**SITE PLAN REVIEW SHEET
ENVIRONMENTAL VARIANCE REQUEST ONLY**

CASE: SP-2019-0170C

PROJECT NAME: Allegro Parmer

Project Name: Allegro Parmer, SP-2019-0170C
 Ordinance Standard: Watershed Protection Ordinance
 Variance Request: LDC 25-8-261 to allow development within a critical water quality zone

B-6

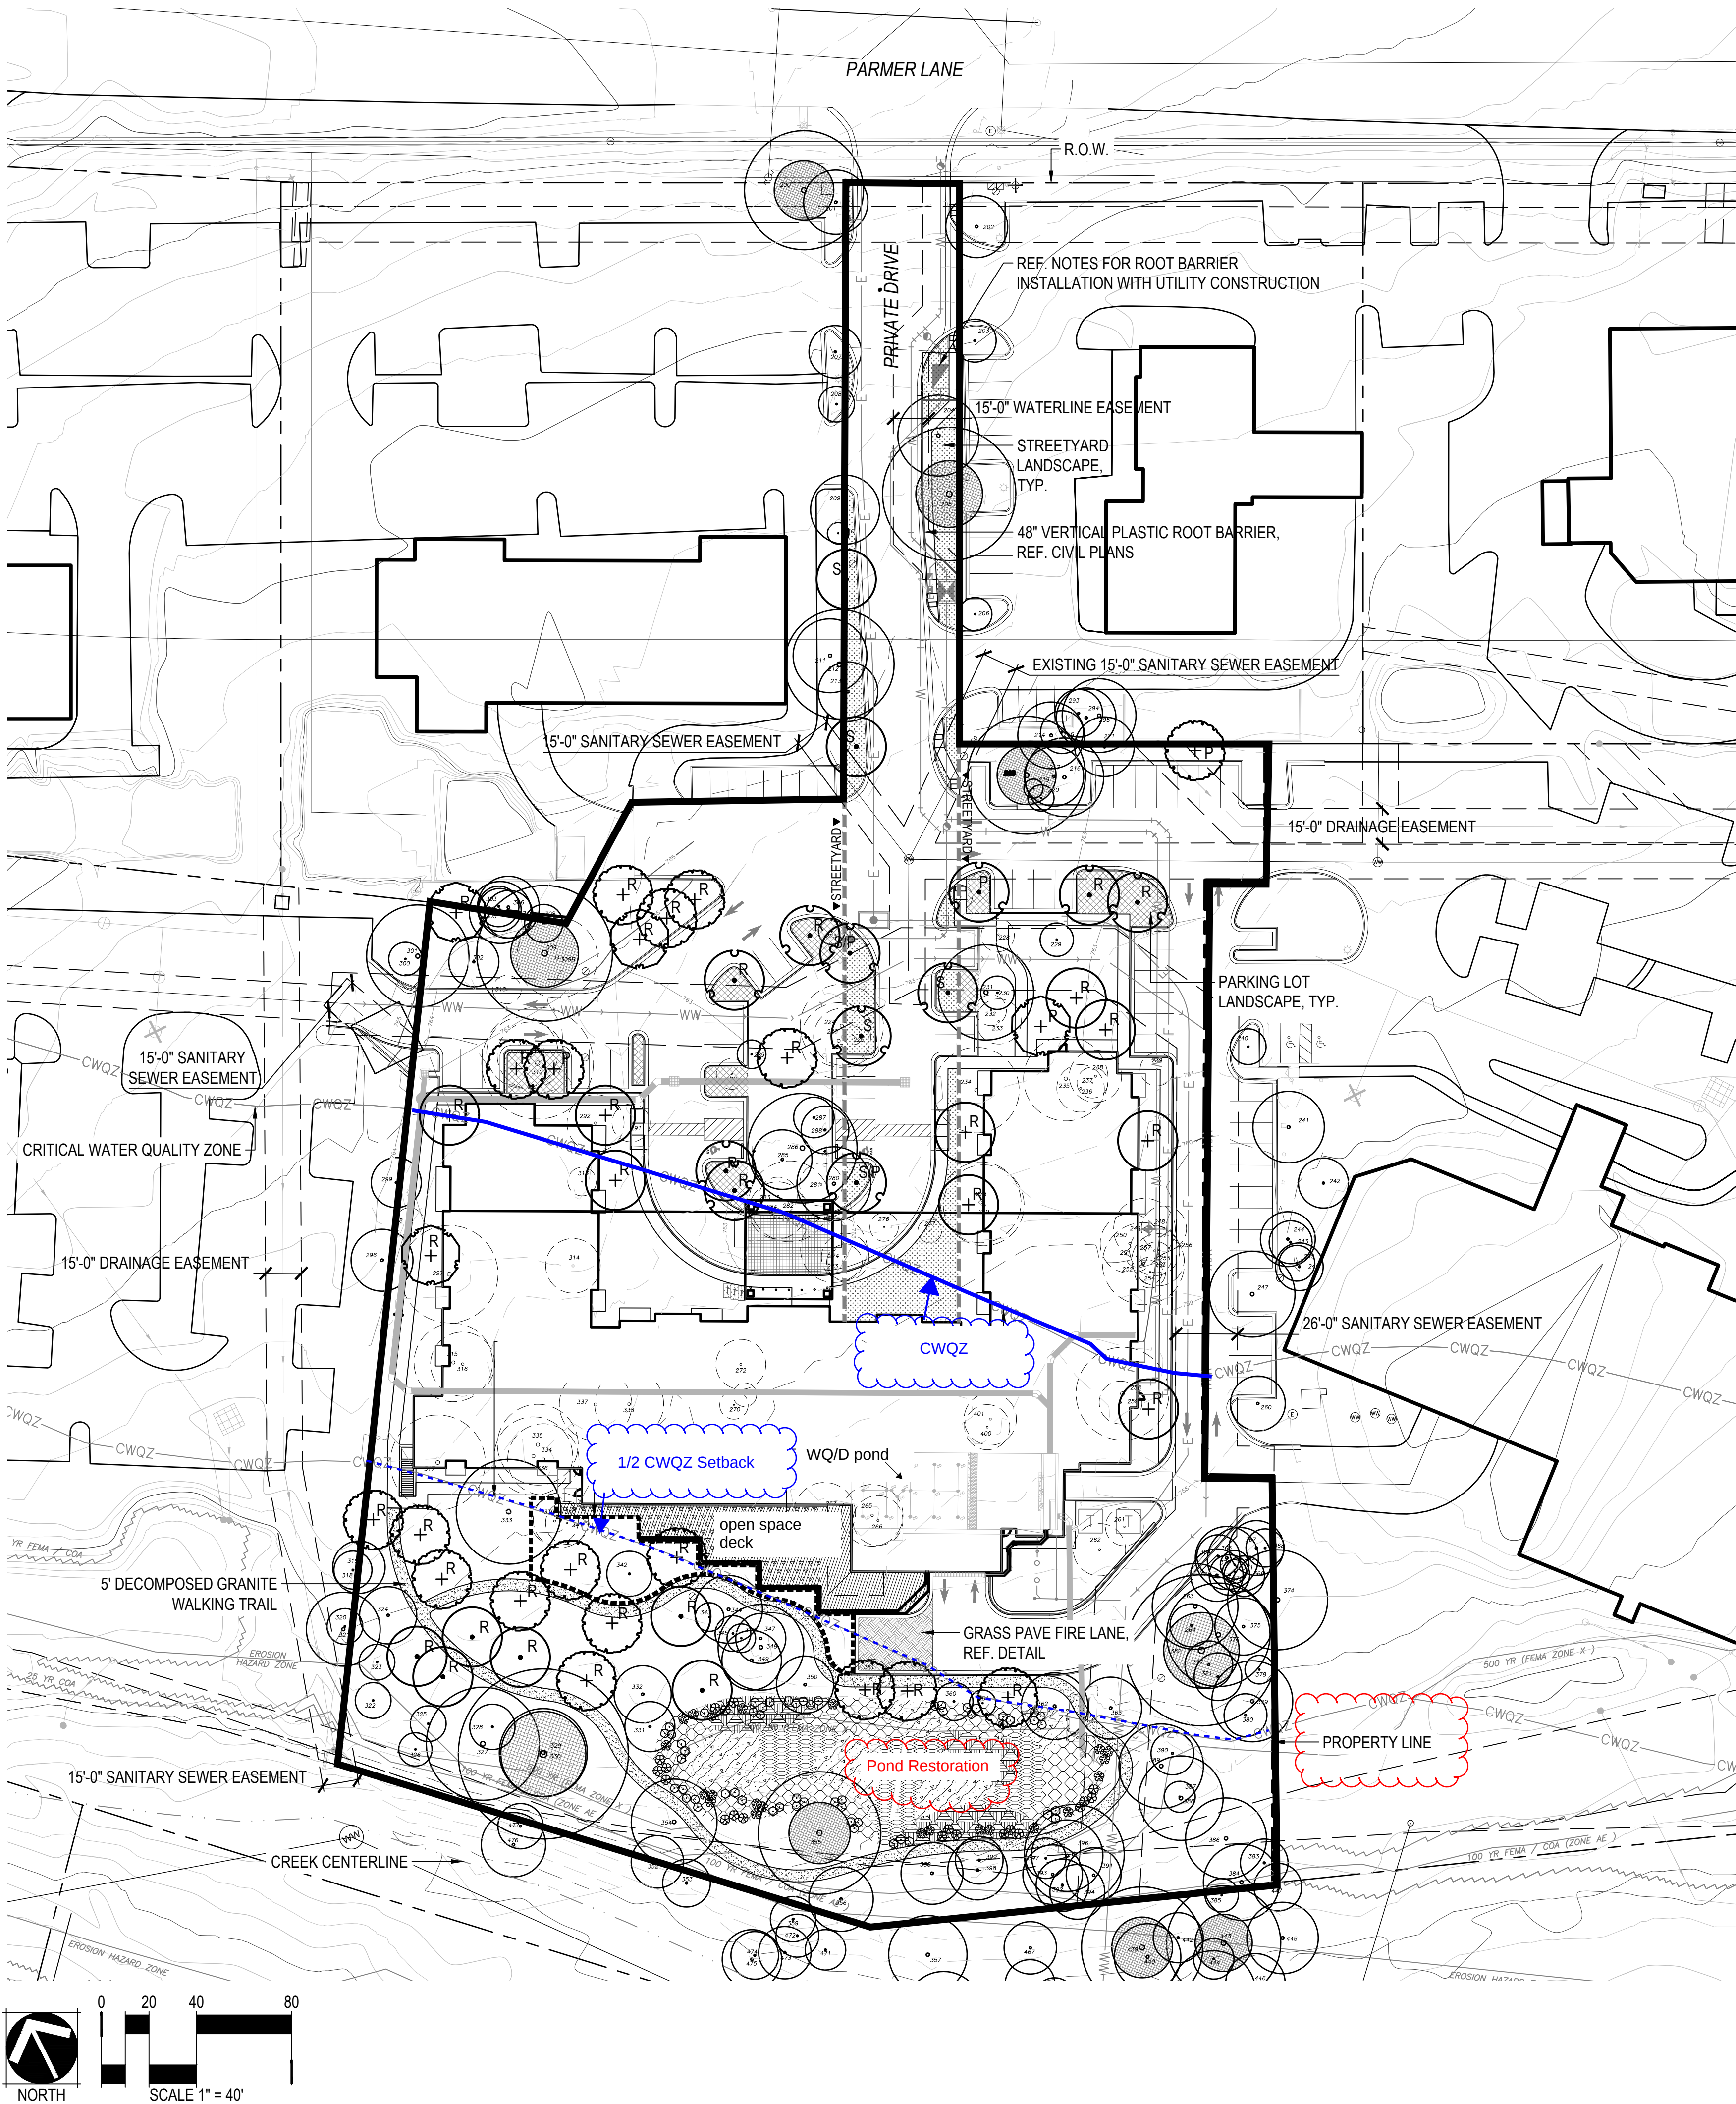
CWQZ
boundary

Half CWQZ

WQ/D
pond
